NEW MEXICO
ENVIRONMENT DEPARTMENT
Surface Water Quality Bureau

RE: Minor Non-Municipal, SIC 9711, NPDES Compliance Evaluation Inspection, USDOE and LANS / Los Alamos National Laboratory, NM0030759, January 31, 2012 - February 3, 2012

NPDES Compliance Inspection Report

**Los Alamos National Laboratory
Individual Stormwater NPDES Permit No. NM0030759
Compliance Evaluation Inspection
January 31, 2012 - February 3, 2012**

Figure 1: NMED Hazardous Waste Bureau map dated March 2002 showing TA-35 affected area, including site 35-016(f) called out for this figure, extending to Mortandad Canyon.

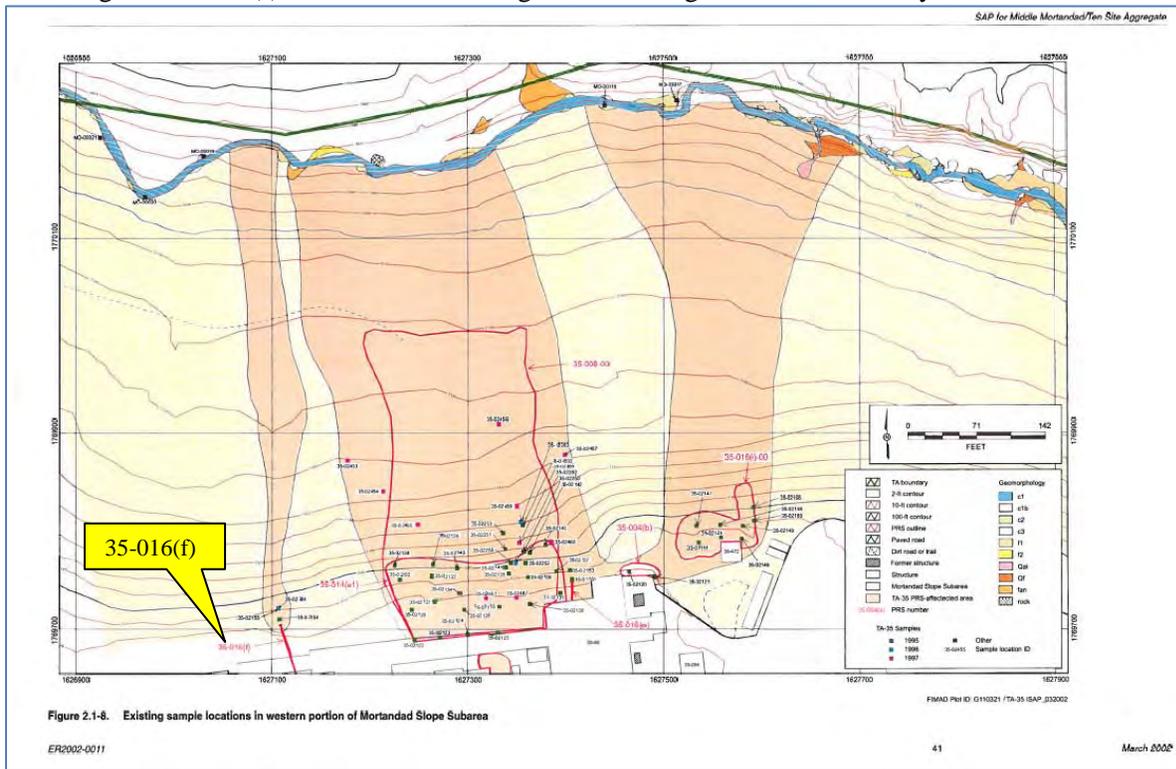
For some sites (e.g., storm drain outlets, outfall, and sumps with sampling locations close to site boundaries), it was not documented that SMA sampling locations would obtain samples that would be representative of the affected area or area subject to corrective action associated with the industrial activity. Specific examples of sample locations that may not be adequate for representative samples are attached. For example, the reason for placing the sampler below and near the 35-016(f) storm drain outlet instead of closer to the known or possible affected area, in this case closer to Mortandad Canyon, is not documented for M-SMA-9.1 (see Figures 1 and 2).
